Notification# 20190121001.0
Datasheet for TS3A5017
Information Only

PCN Number:	20190121001.0	**PCN Date:**	January 29, 2019
Title:	Datasheet for TS3A5017		
Customer Contact:	PCN Manager	**Dept:**	Quality Services

TS3A5017

SCDS188G – JANUARY 2005 – REVISED JANUARY 2019

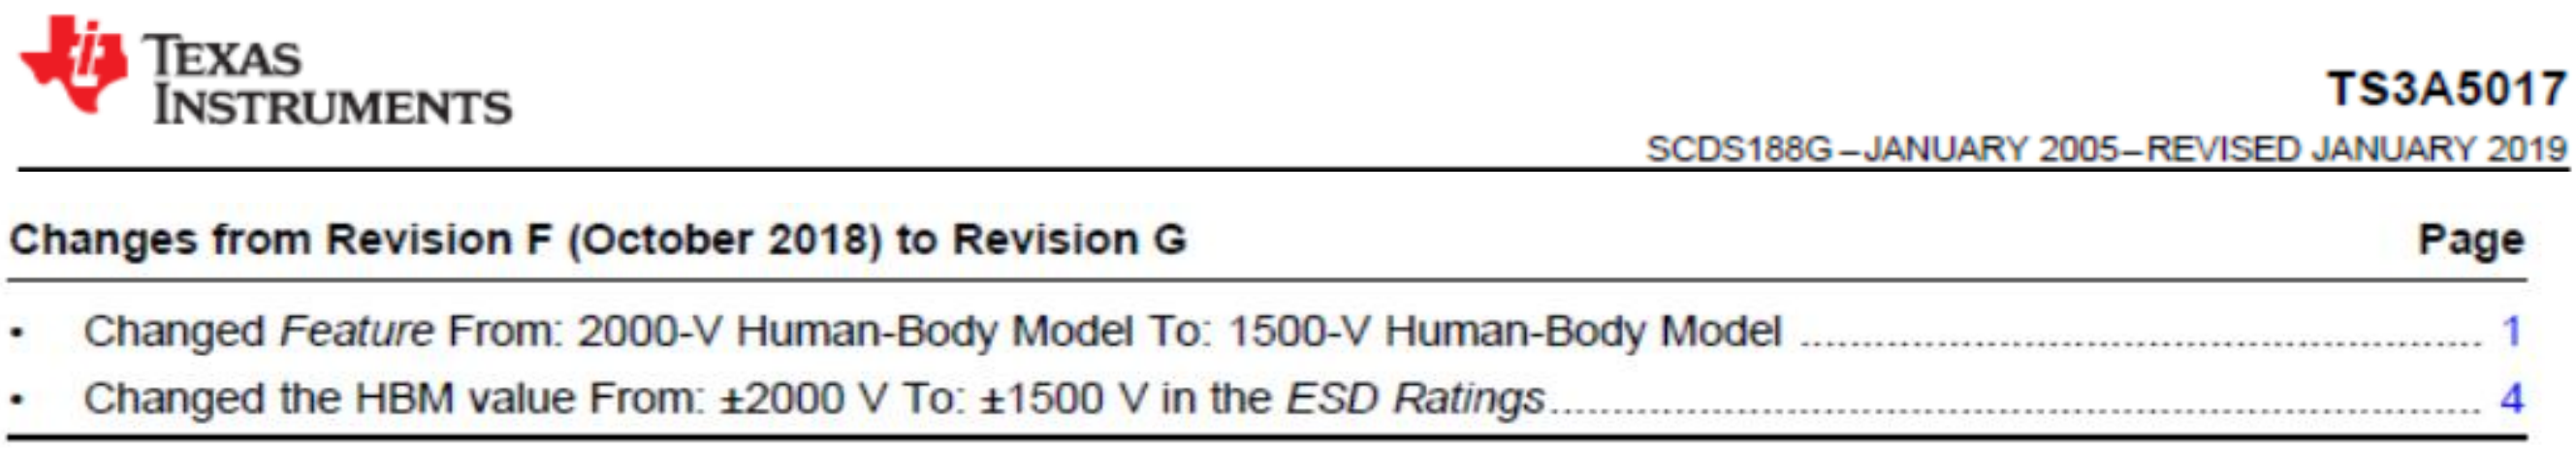
Changes from Revision F (October 2018) to Revision G **Page**

- Changed *Feature* From: 2000-V Human-Body Model To: 1500-V Human-Body Model 1
- Changed the HBM value From: ±2000 V To: ±1500 V in the *ESD Ratings* 4
